# City of Sandy

### Planning Commission Meeting

**Meeting Date:** Tuesday, December 3, 2019

**PROJECT:** SPACE AGE SERVICE STATION  
**TREE RETENTION PLAN**  
**LOCATION:** 15585 SE ORIENT DR, SANDY, OR 97055

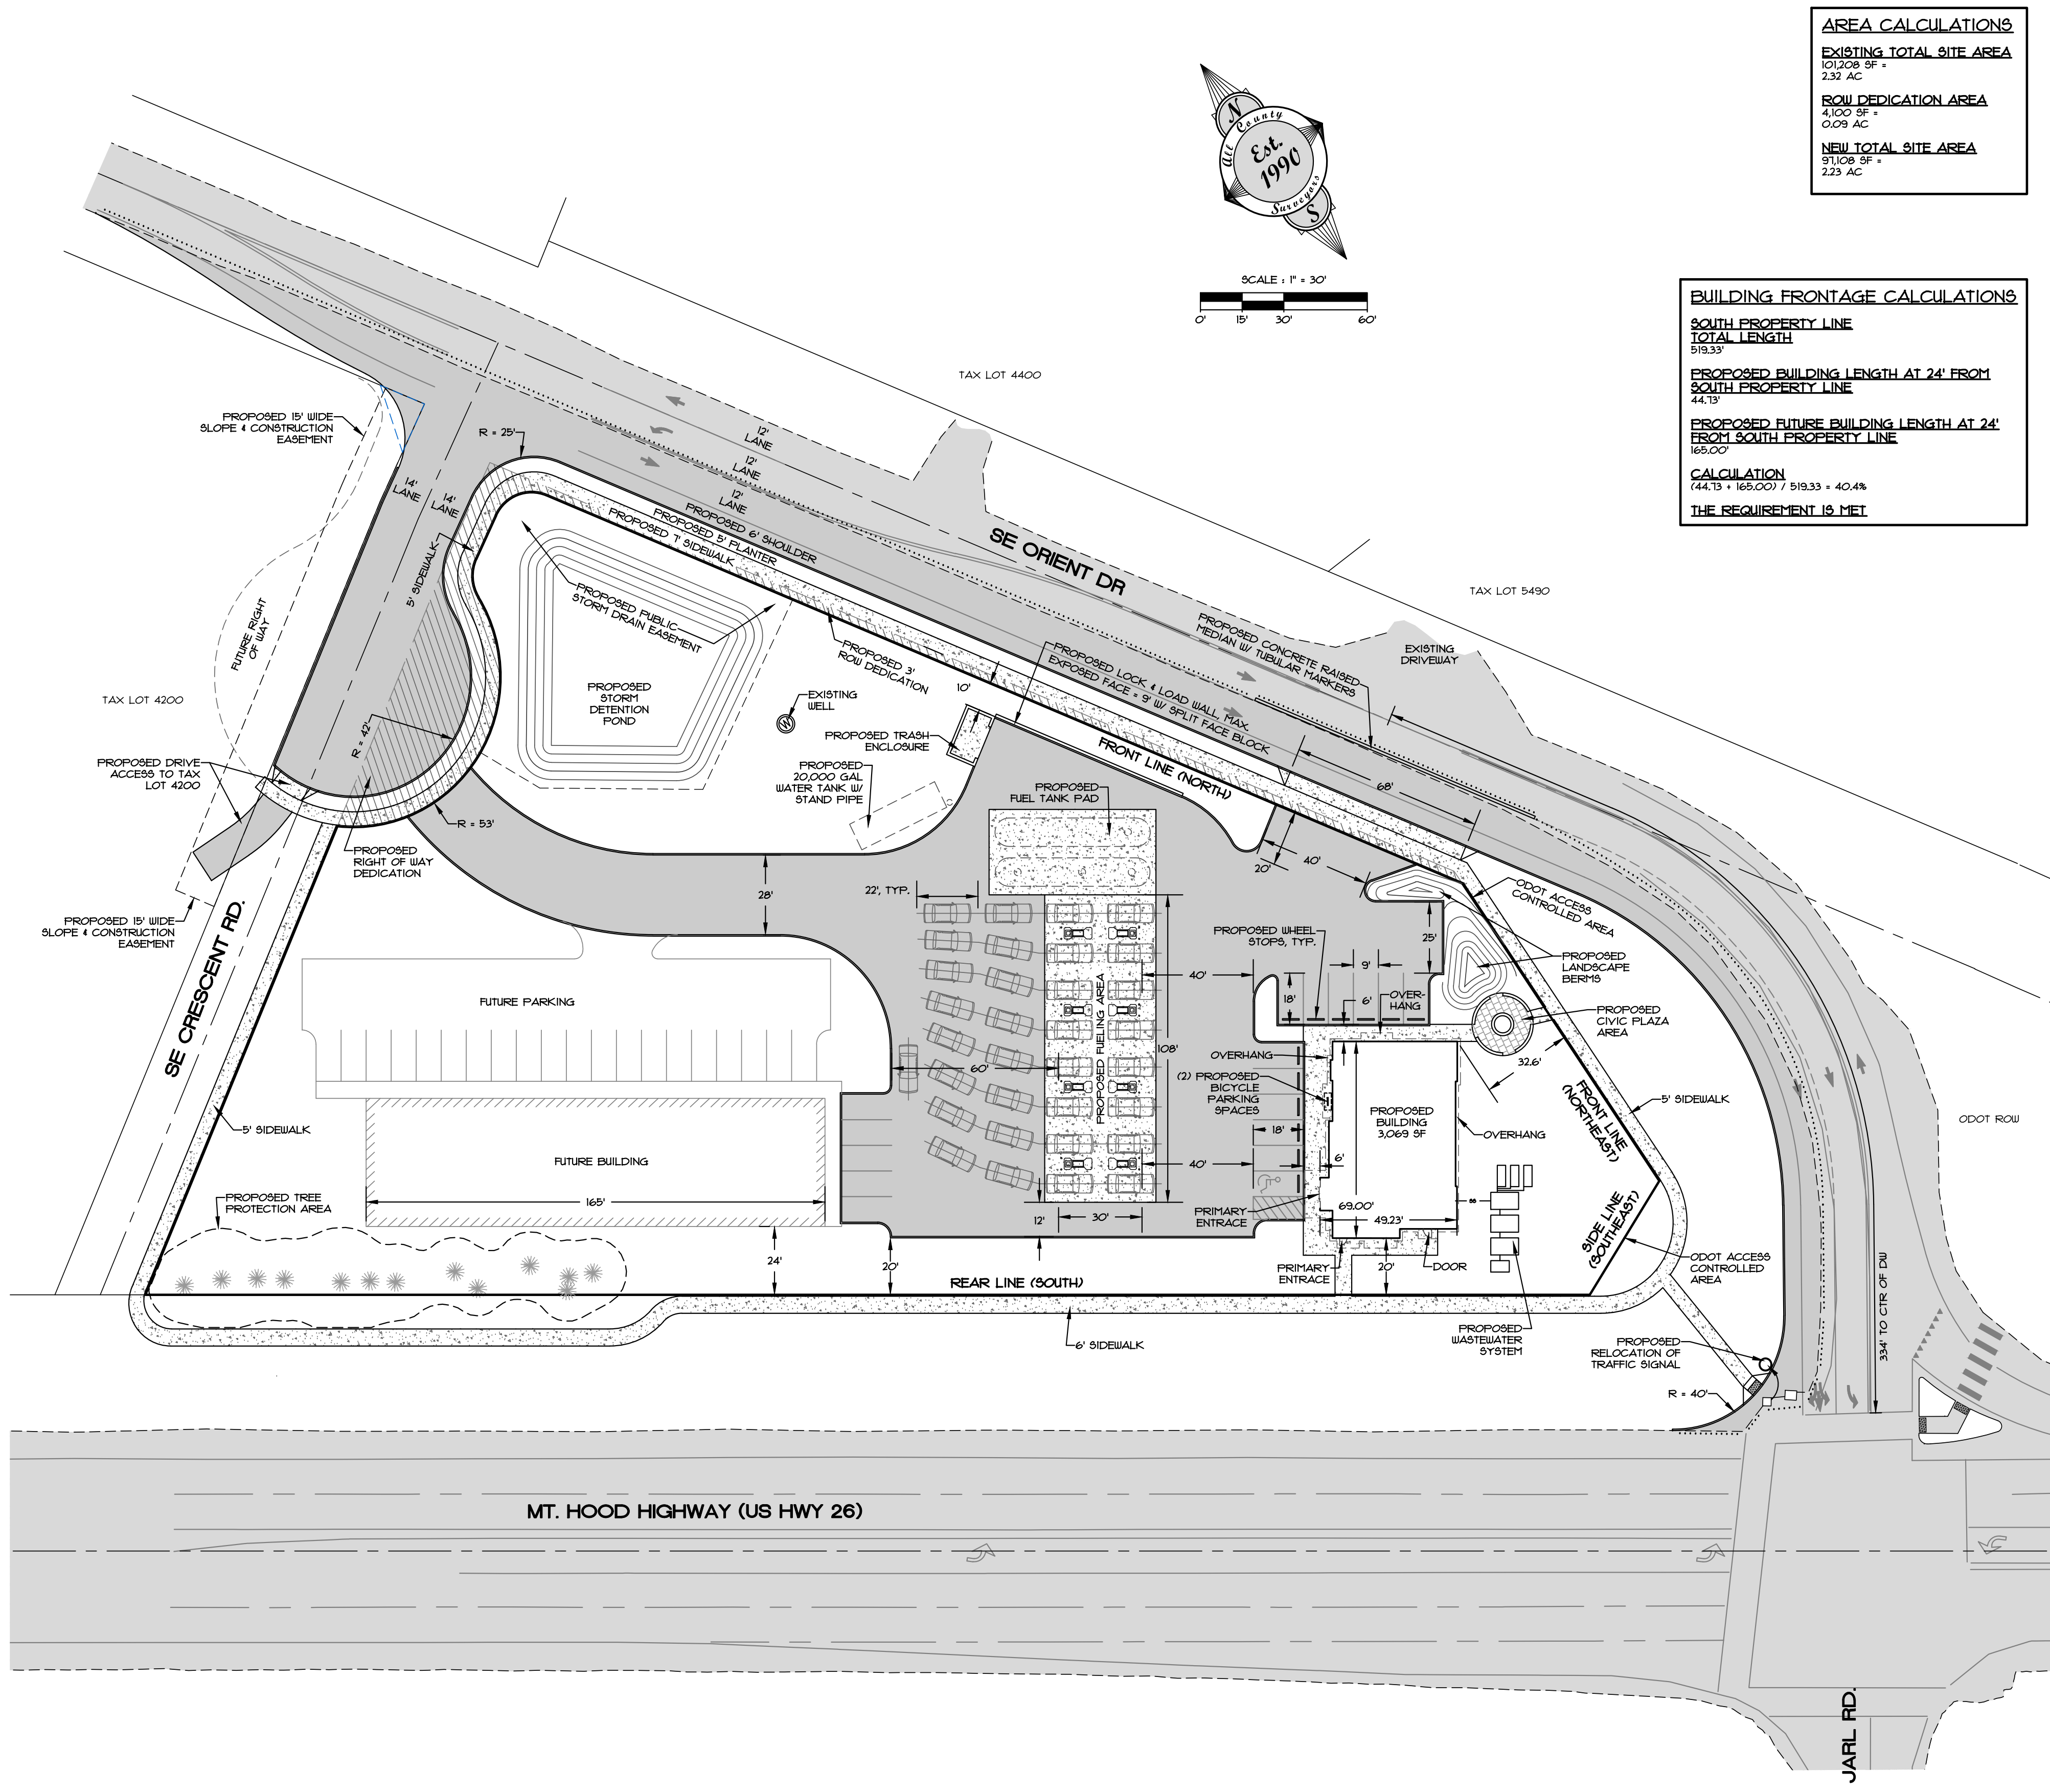
Staff finds that in order to adequately protect the proposed retention trees, the future building would need to be set back further than 24 feet. The submitted Tree Retention Plan (Exhibit D, Sheet 2) and arborist report (Exhibit I) detail the critical root zone around the retention trees at 0.5 feet per 1 inch DBH. However, the industry standard for an adequate critical root zone is 1 foot per 1 inch DBH; thus, the tree protection area will need to be expanded in order to adequately protect the proposed retention trees such that they will remain healthy and likely to grow to maturity. The third-party arborist report (Exhibit W) recommends that tree protective fencing be installed consistent with the one foot per inch diameter formula. The originally submitted Arborist Report (Exhibit I) and the Tree Protection Addendum submitted with the applicant's appeal (Exhibit CC) both show the tree protection fencing at 1 foot per 1 inch DBH. While the Tree Protection Addendum confirms that no more than 25 percent of the area within each tree's root protection zone of 1 foot per 1 inch DBH will be impacted, staff would like to reiterate that the applicant is not planning to construct the proposed future building at this time, nor is it anticipated that the applicant will construct the proposed future building at any point in the near future as this would most likely require extending the sewer line to the subject property. Therefore, staff would prefer to see the least amount of proposed impact within the root protection zone of 1 foot per 1 inch DBH as possible. Staff believes that setting the proposed future building back more than 24 feet would better protect the retention trees by minimizing construction activity within the 1 foot per 1 inch DBH root protection zone. Staff finds the future building footprint shall be relocated at a sufficient setback to not adversely affect the retention trees. This would require a Variance as the distance would be greater than a 20 percent increase from the 20 foot setback required by Section 17.90.120 (D.1). If staff processed the adjustment per the applicant's request staff would deny the adjustment as staff has no evidence the proposed location at 24 feet would ~~adequately~~ protect the retention trees as well as or better than if the building was placed outside of the critical root zone of 1 foot per 1 inch DBH. While staff acknowledges that up to 25 percent of the area within the 1 foot per 1 inch DBH root zone can be impacted, staff believes the best practice is to minimize negative impact to the roots within this area. Because this project is on an individual lot of record and because the recommendation to increase the setback is not of the applicant's making, this can be processed as a Type II Variance.

PROJECT: **SPACE AGE SERVICE STATION GRADING PLAN AND EROSION CONTROL PLAN**

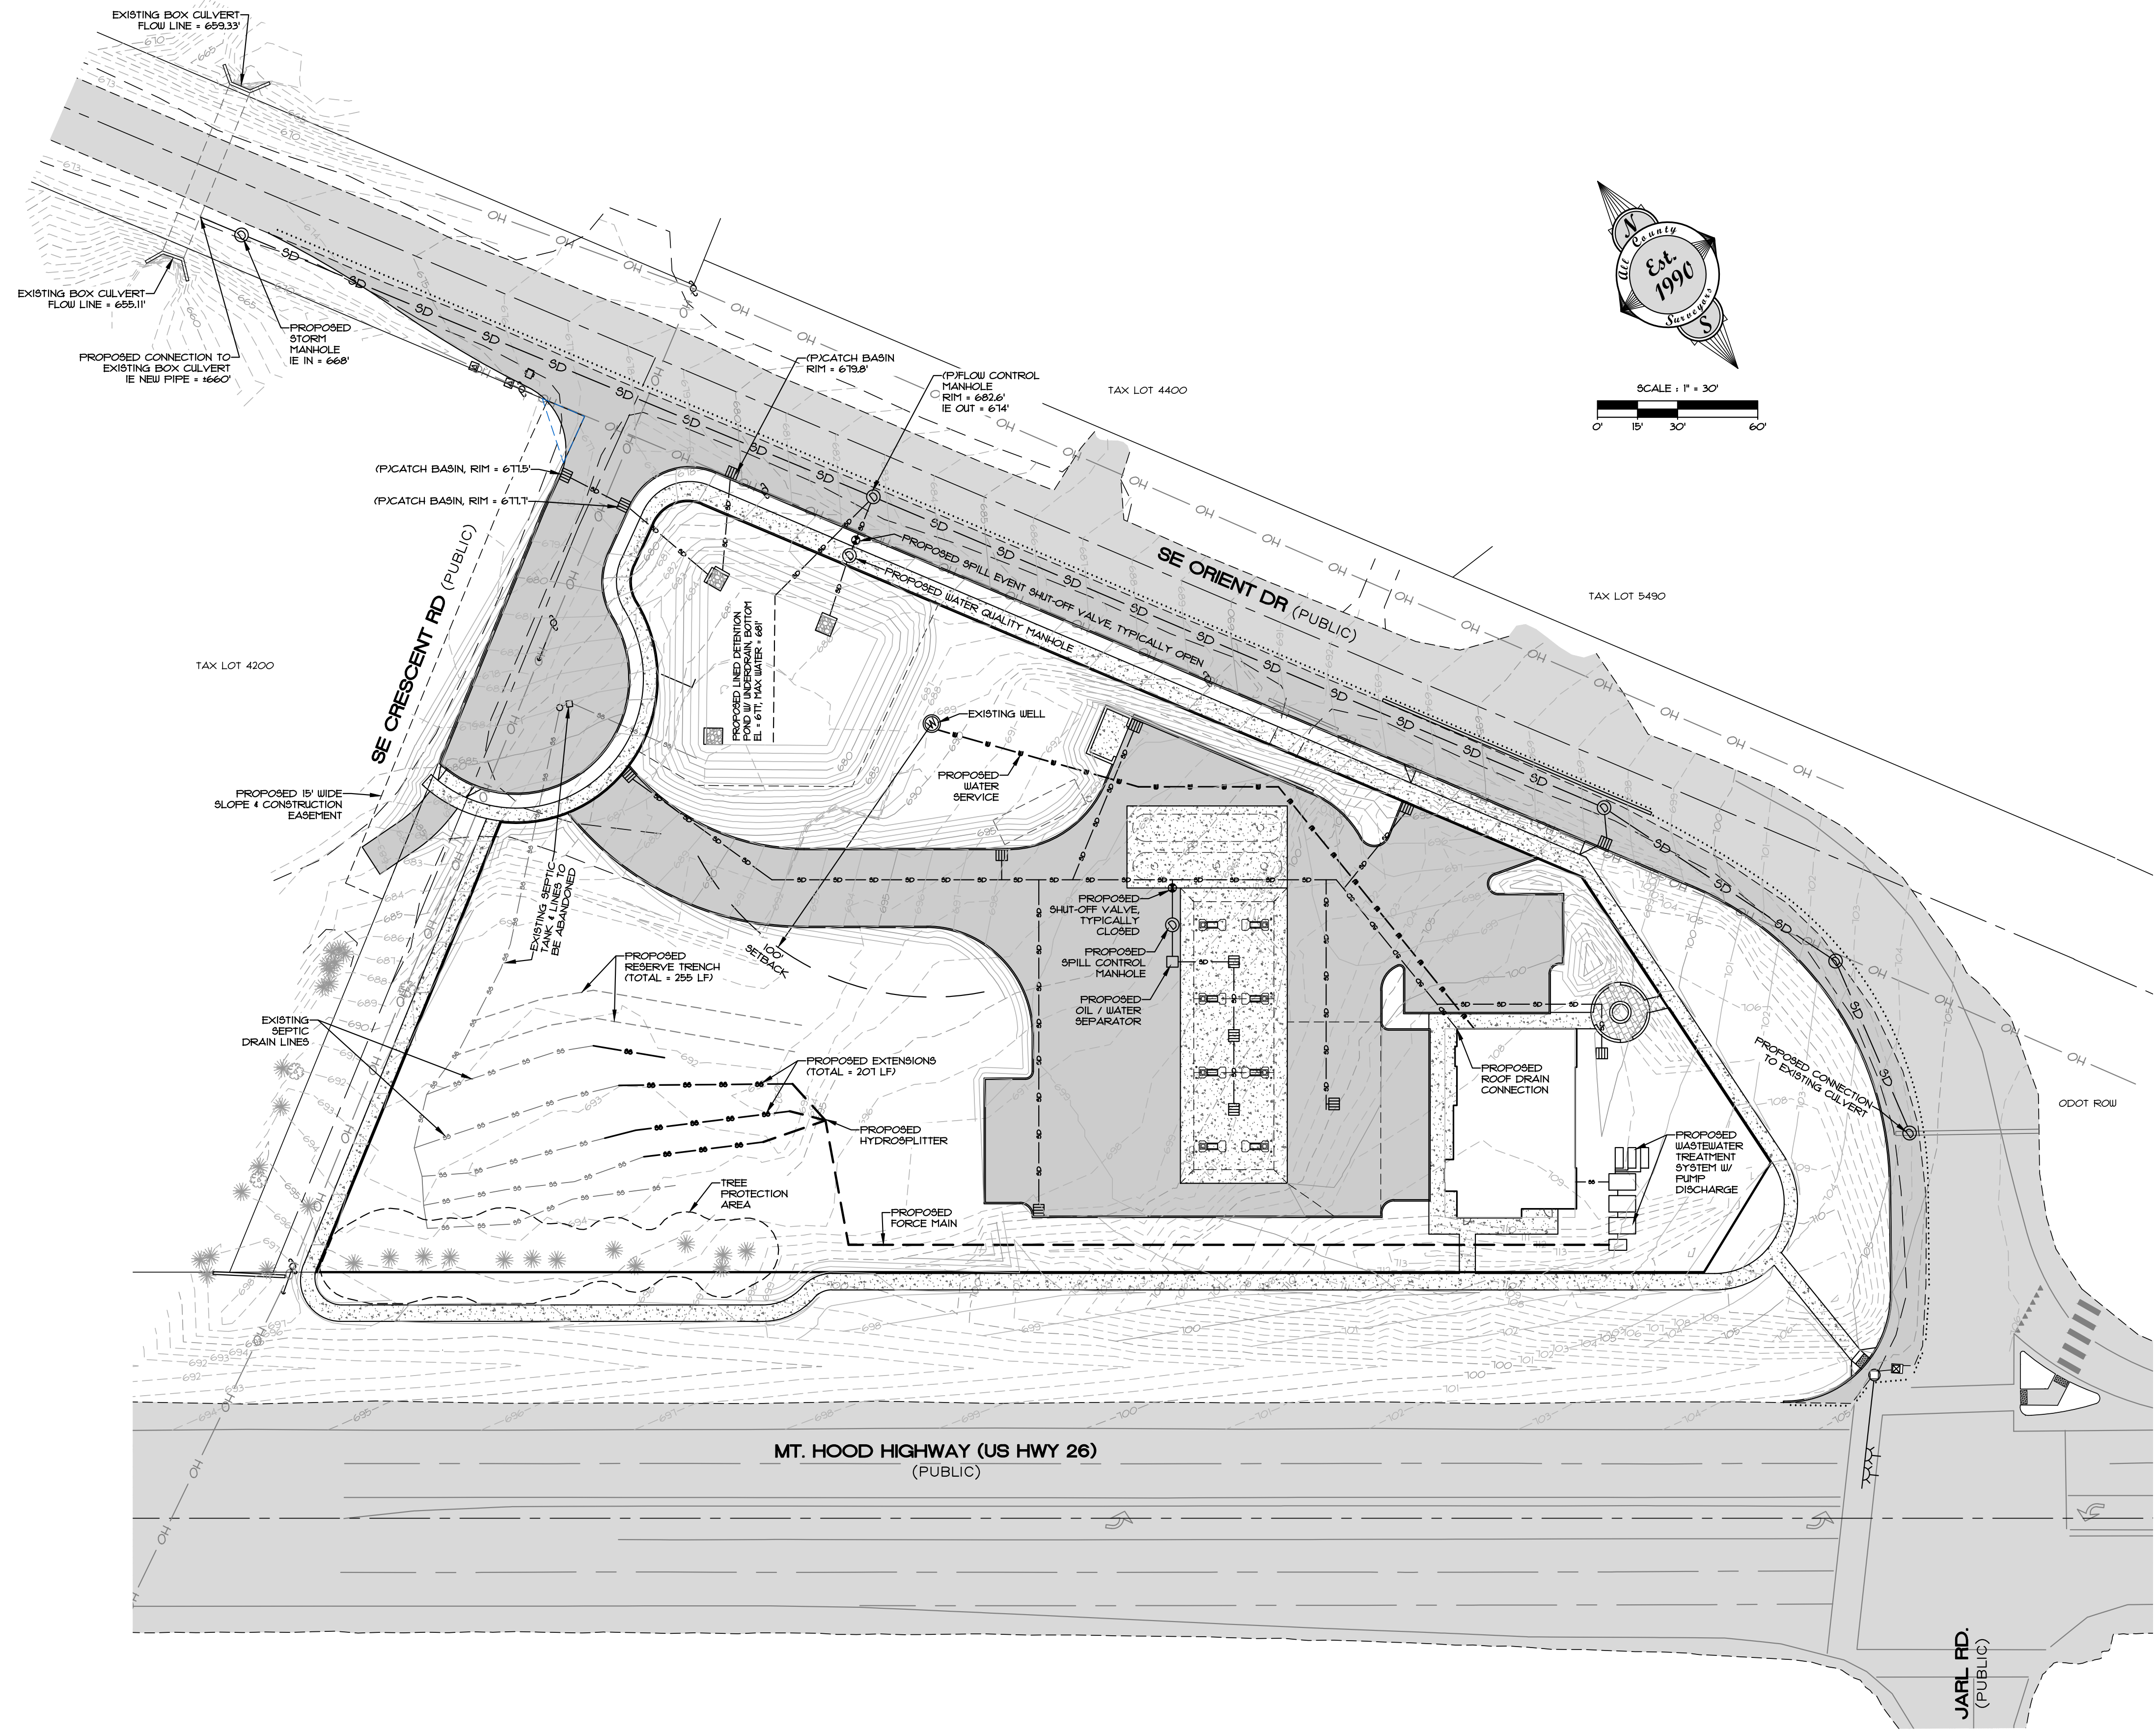
~~17.~~ Section 17.84.30(A) requires setback sidewalks with a minimum width of six feet along arterial streets such as Highway 26 and Orient Drive. The Site Plan (Exhibit D, Sheet 3) indicates the applicant will install 6 foot wide sidewalks along Highway 26 and 5-7 foot

sidewalks along the Orient Drive frontages of the site. Both Highway 26 and Orient Drive are arterial streets; therefore, the minimum sidewalk width is 6 feet per Section 17.84.30(A.2). The standard sidewalk width for sidewalks on ODOT arterials is 6 feet and the standard sidewalk width for sidewalks on Clackamas County arterials is 7 feet. **The applicant shall update the plan set to detail 6 foot wide sidewalks along the Highway 26 frontage and 7 foot wide sidewalks along the Orient Drive frontage of the site.** Per the City Engineer (Exhibit O), **all sidewalks and ADA ramps shall comply with the most current ADA requirements. An ADA ramp shall be installed at the corner of SE Orient Drive and SE Crescent Road. The applicant shall contact the ODOT District Contact (Loretta Kieffer, 503-667-7441) to determine permit requirements and obtain application information. If a design exception is required for street trees the applicant shall adjust the location of the sidewalk to allow street trees that meet ODOT's minimum clear zone criteria and/or apply for a design exception. There appears to be sufficient right-of-way to meet ODOT's clear zone criteria. Any costs for a design exception shall be paid by the applicant.** ODOT (Exhibit T) states that the site plan shows a single ADA ramp at the intersection of Highway 26 and Orient Drive but the ODOT standard is for two ADA ramps. **The applicant shall update the plan set to detail two ADA ramps at the intersection of Highway 26 and Orient Drive.**

1. Submit a revised Site Plan and supplemental Plans to include all changes as identified in this Order including:
  - Detail 6 foot wide sidewalks along the Highway 26 frontage and 7 foot wide sidewalks along the Orient Drive frontage of the site.
